Announcement of Design Number Change for Pneumatic Swing Clamp (model WHC)

Design number [Model number] has been updated as below for adding long stroke model.

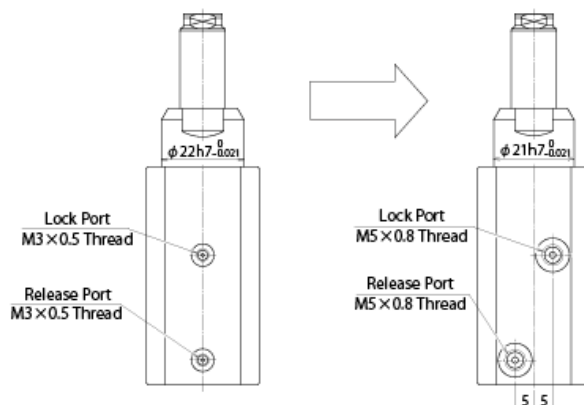
- Anodized aluminum finishing color on cylinder part is changed from red to white.
- Only for WHC0201, there are 2 changes in dimensions.
Port size M3 is changed to M5, and port positions are also changed.
φ22h7 part is changed to φ21h7. (It is interchangeable with existing item.)

- For WHC0321/0401, the change is the color of outside appearance only.
It is interchangeable with existing item.
